BGA Package Analysis

IEEE 802.3ap Backplane Task Force

June 2005

Basic Model from latest package info (Mellitz02_05_05)

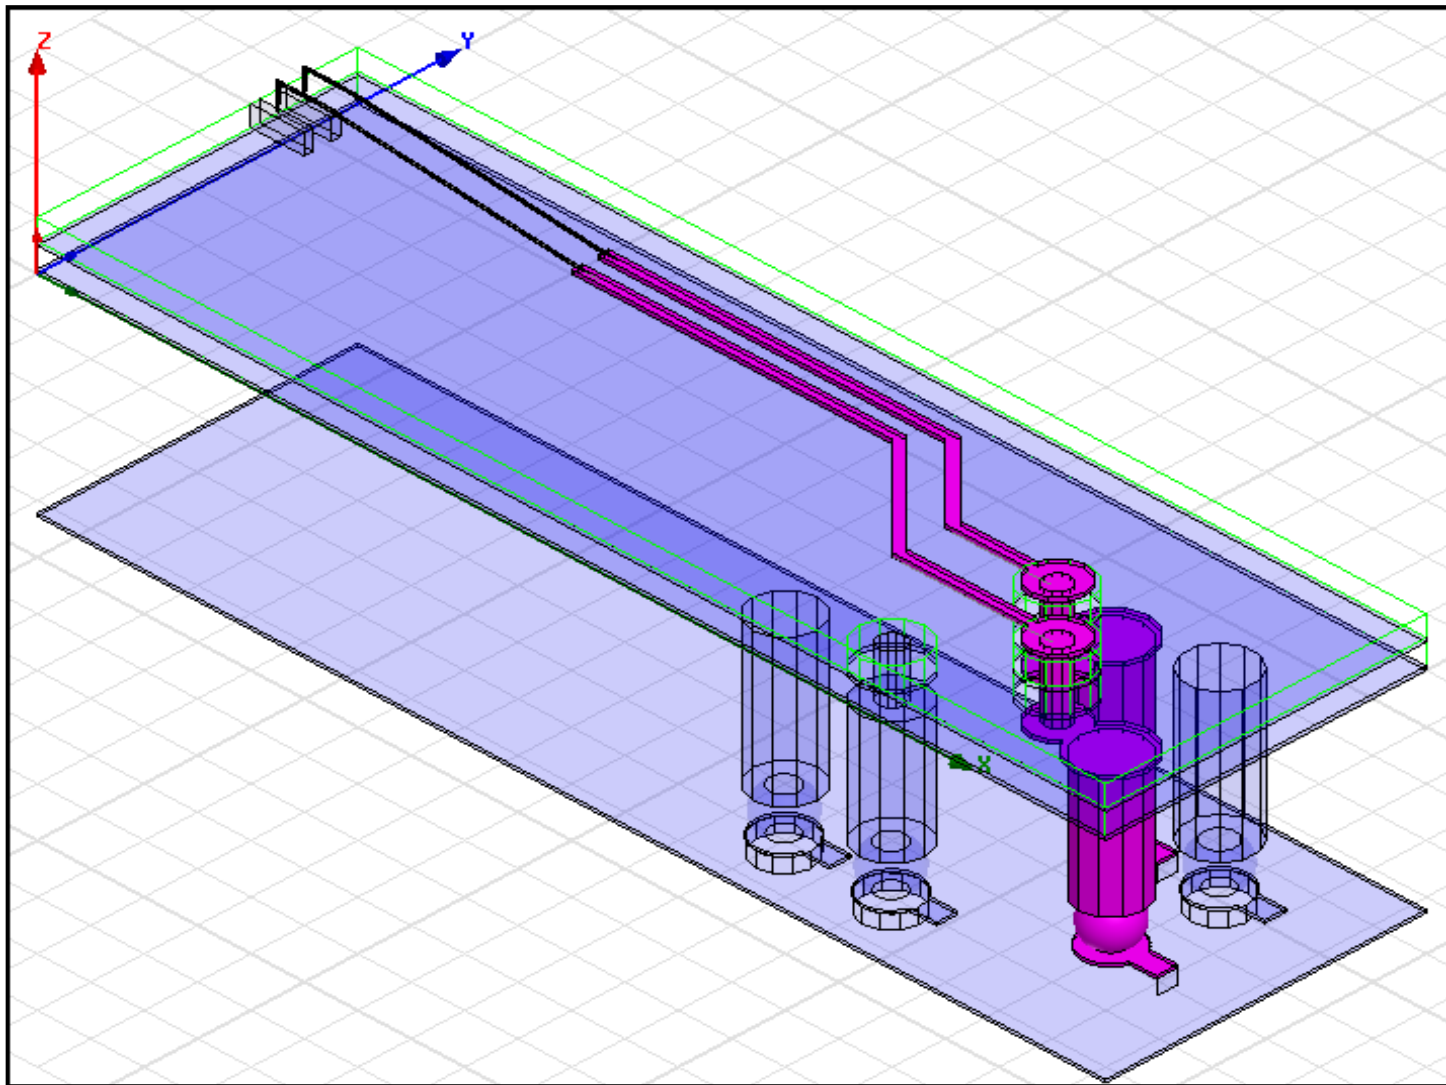
- Current package model seems to offer two flavors , both an inductive like and cap like model
- Current model based upon specs that are (measured?) from previous estimates
- Verification of these numbers modeled for a sanity check

Updated graph Adjusted Spec

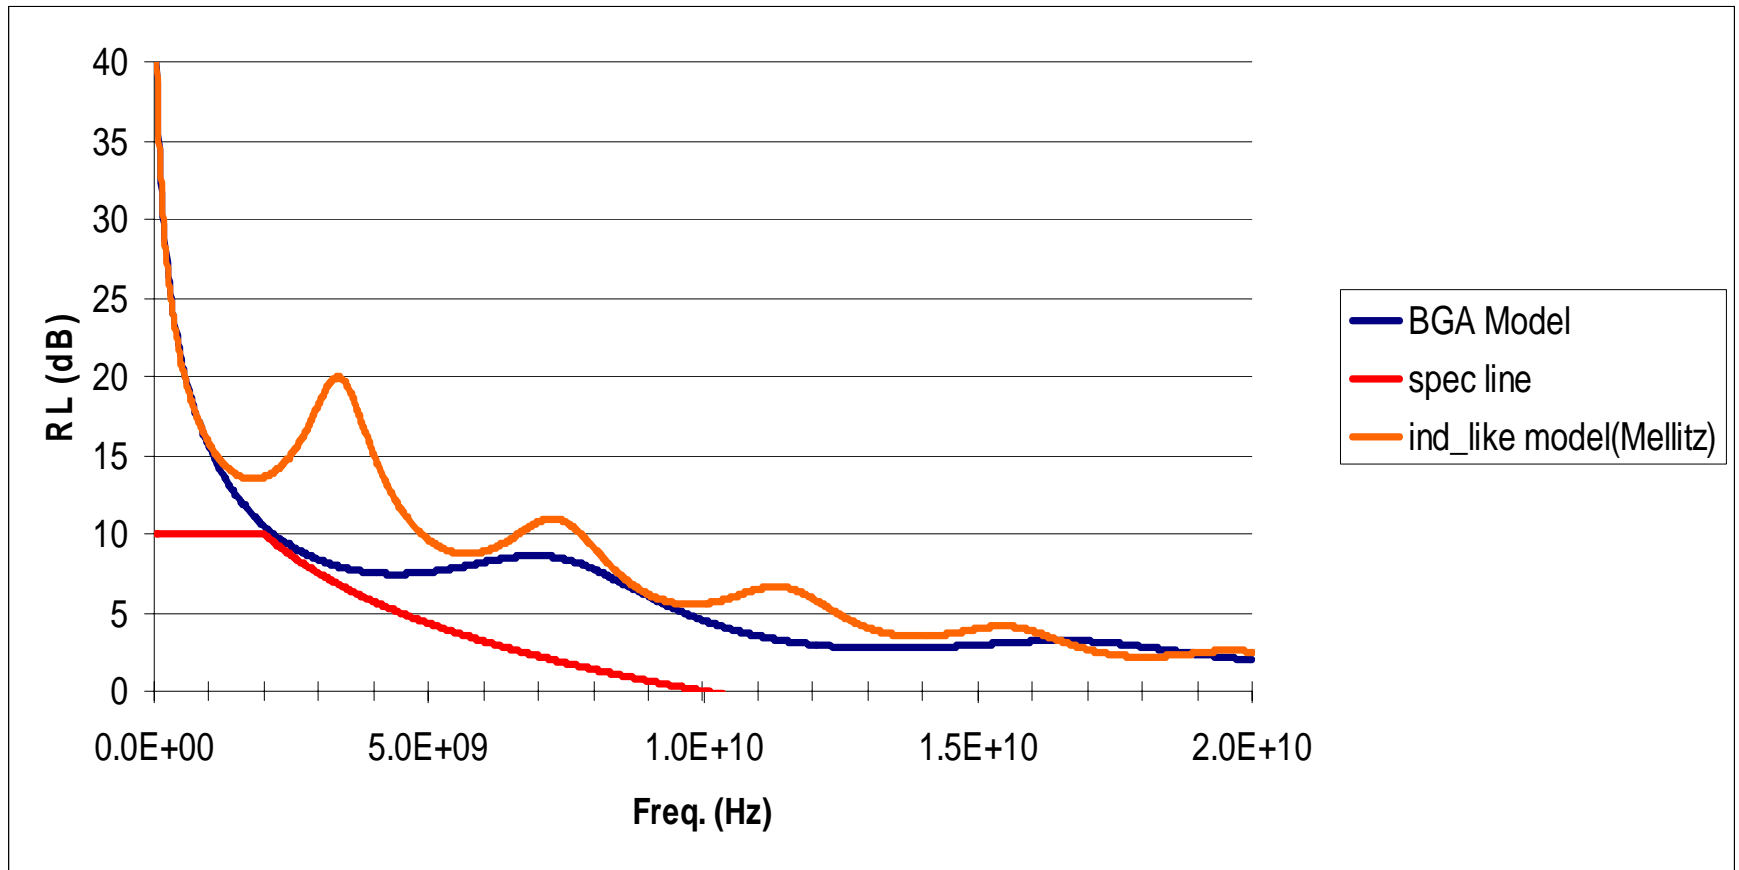
- RL results show similar falloff but a problem at the corner of the suggested RL spec
- Recommend that RL spec be adjusted ($RI5 - 14.31 * \log(x/F_{br})$) slightly to compensate based upon results of package model analysis

Adjusted spec: $F_{br}=2\text{GHz}$, $RI5 = 10\text{dB}$

If($X < F_{br}$, $RI5$ else ($RI5 - 14.31 * \log(X/F_{br})$)
